**CITY OF LA VISTA  
PLANNING DIVISION**

**RECOMMENDATION REPORT**

CASE NUMBER: 2015-CUP-02  
2015-PUD-04

RE: Comfort Suites Design Review #1

**R3.1**

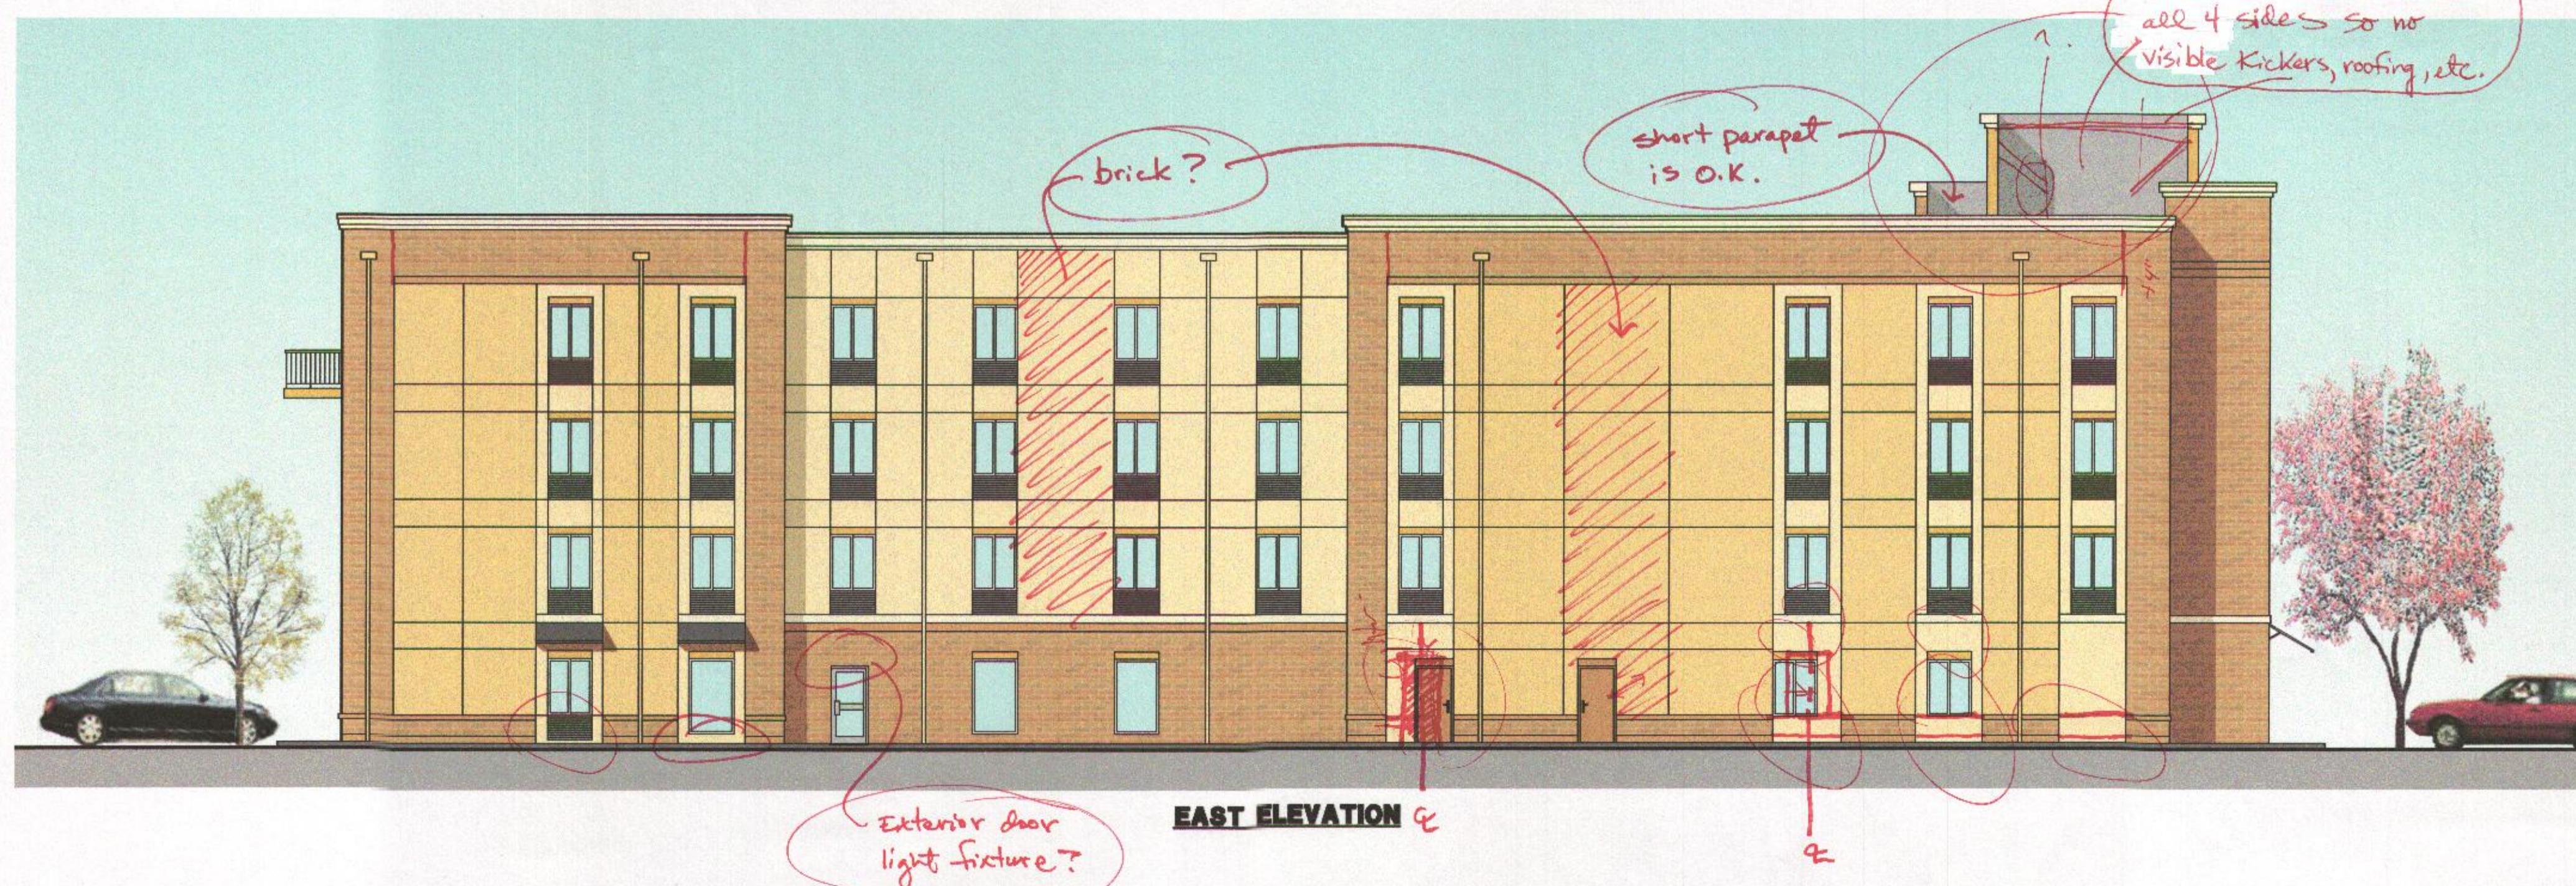
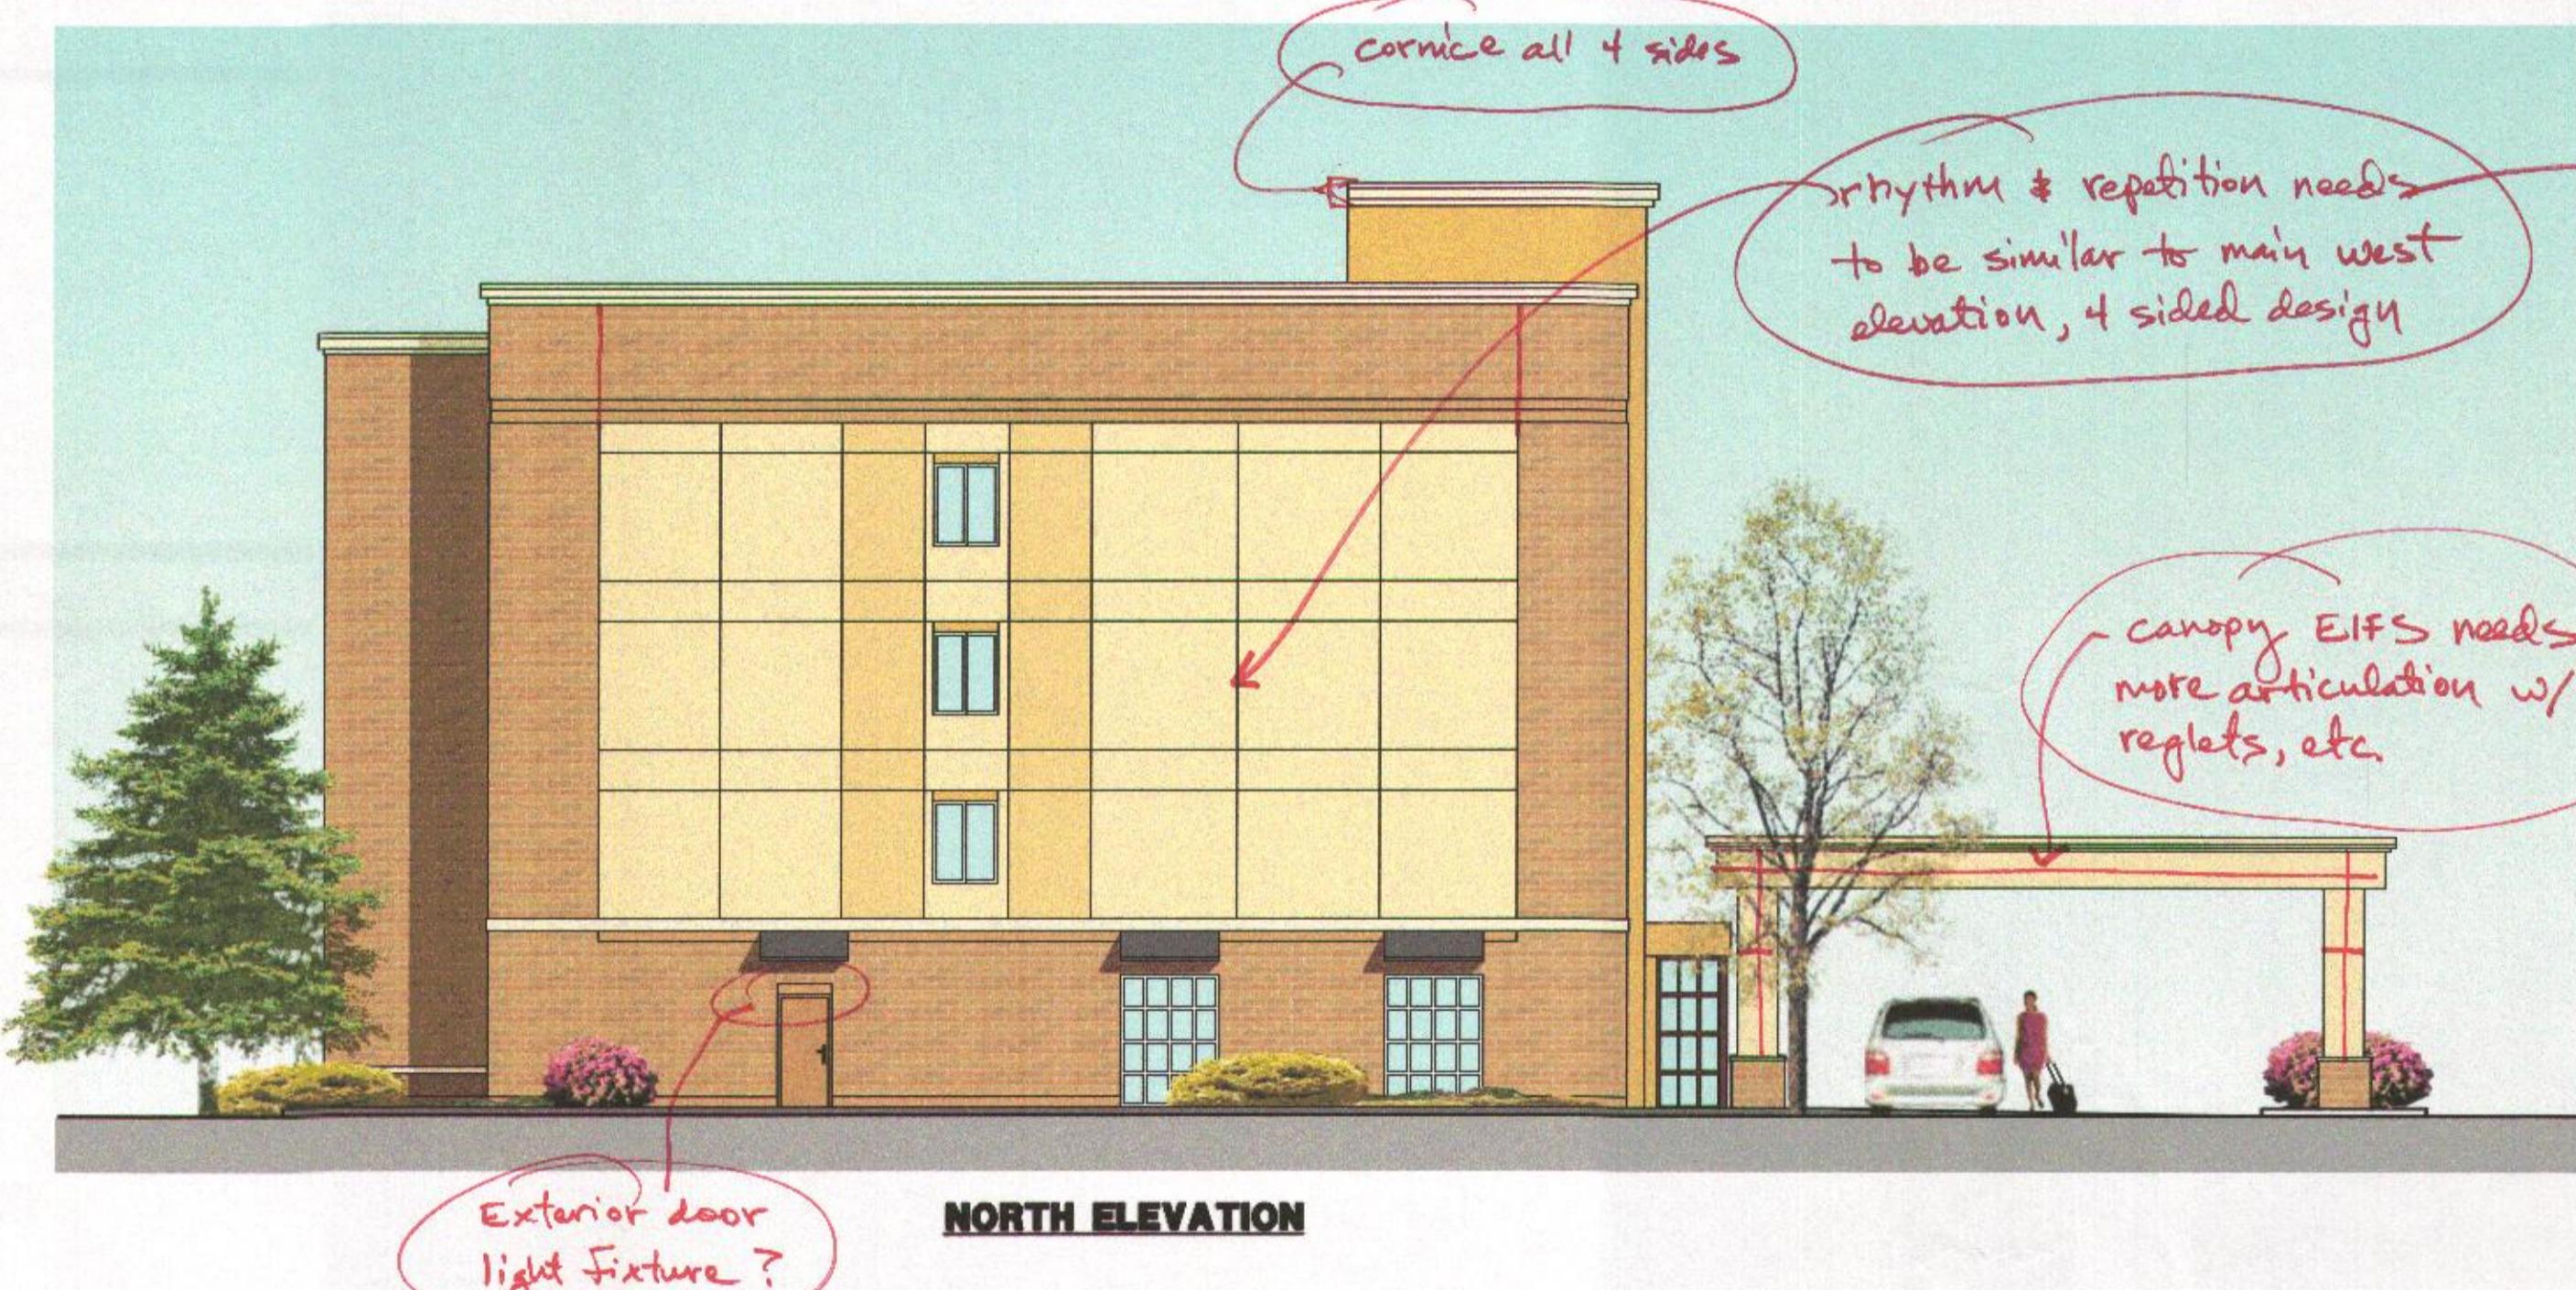
1. See attached scan with annotated recommendations in red.
  - a. La Vista requires 4 sided design. Review all 4 elevations for consistency of rhythm and repetition of elements and materials.
  - b. Overall percentage of brick appears short of 60% requirement in the mid-facade. (Refer to Paragraph 5.II.D.2.b.)
  - c. Vertical areas where EIFS extends down to grade appear out of place with brick base banding and could present maintenance issues.
  - d. Consistency of awnings needs to be reviewed.
  - e. Show the size/scale of the arbor element in the renderings or separate rendering.

- Percentage of Brick? 60%?
- Consistency of awning locations?
- Show arbor in renderings.
- 4 sided design required.

# PLANNED UNIT DEVELOPMENT SITE PLAN

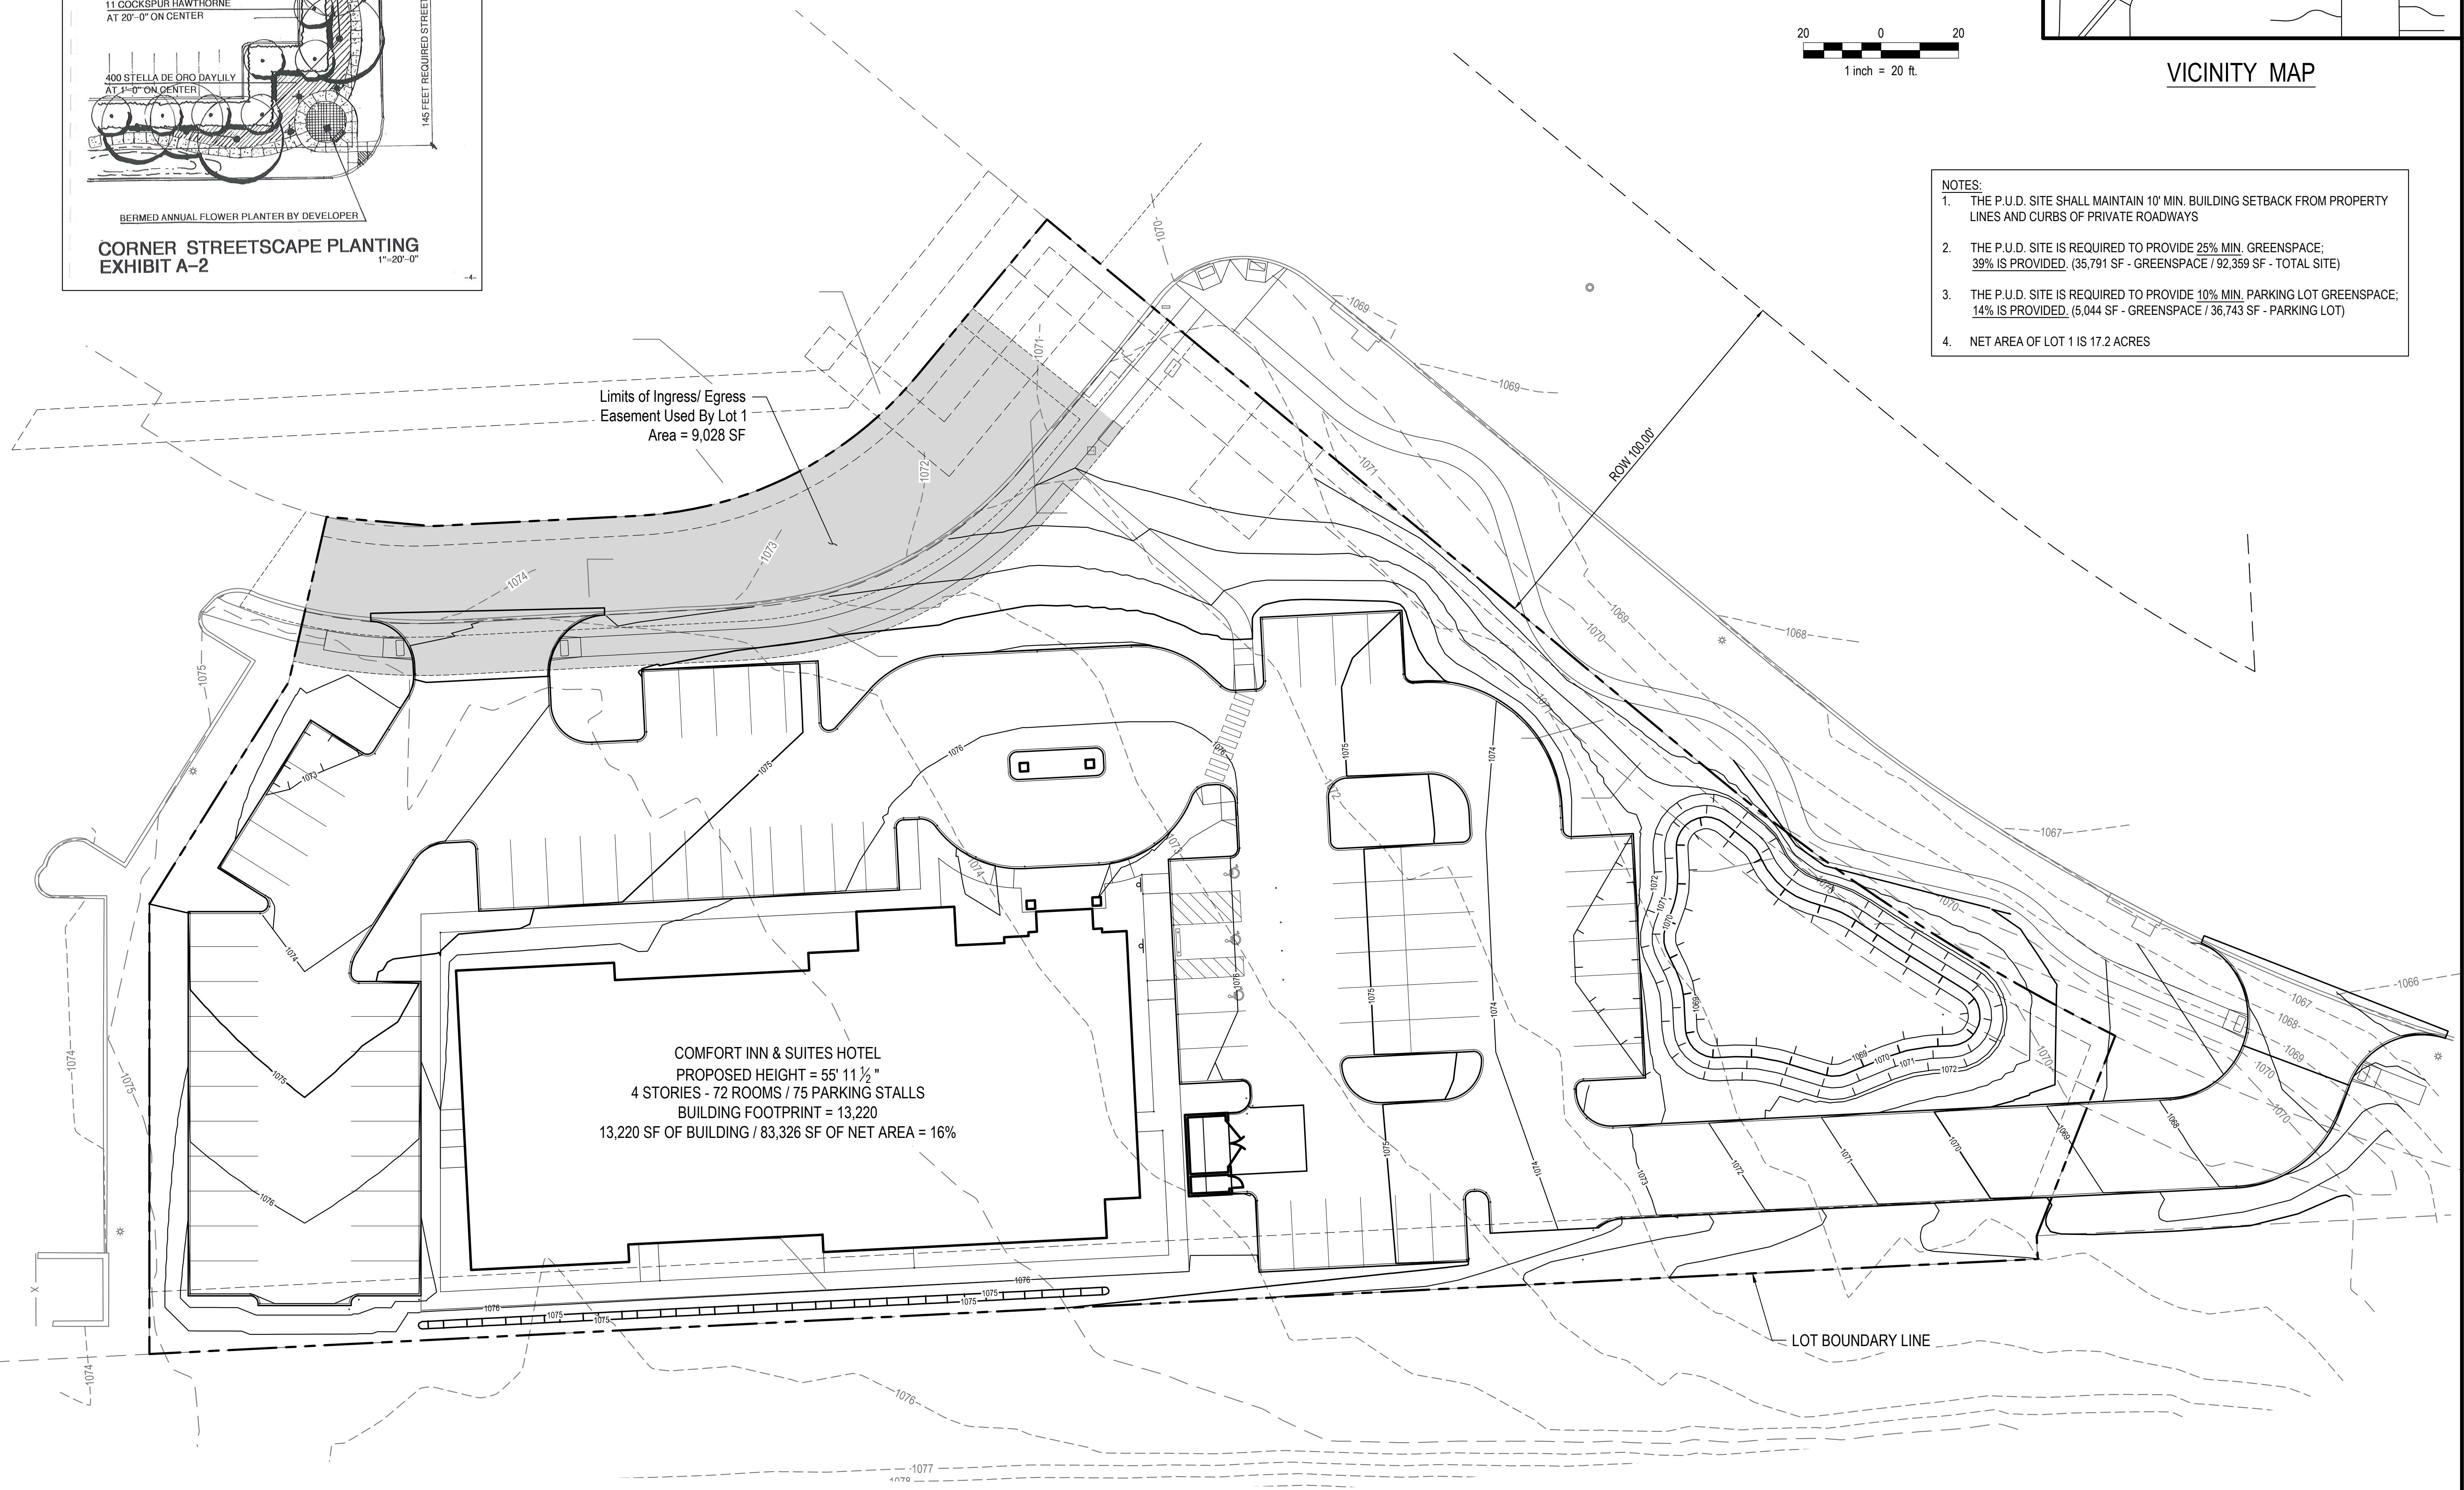
1. South parking stalls are too close to the property line and do not allow for the required 10' green space and planted screening. Coordinate with Landscape Plan L1. (Refer to Appendix E. Interior Property Line Plantings)
2. West sidewalk layout does not match the more current layout shown on Civil PAVING AND LAYOUT PLAN.
3. East sidewalk and parking stalls to the north do not allow for the required 10' green space and planted screening if the future street is constructed as indicated on the plans.
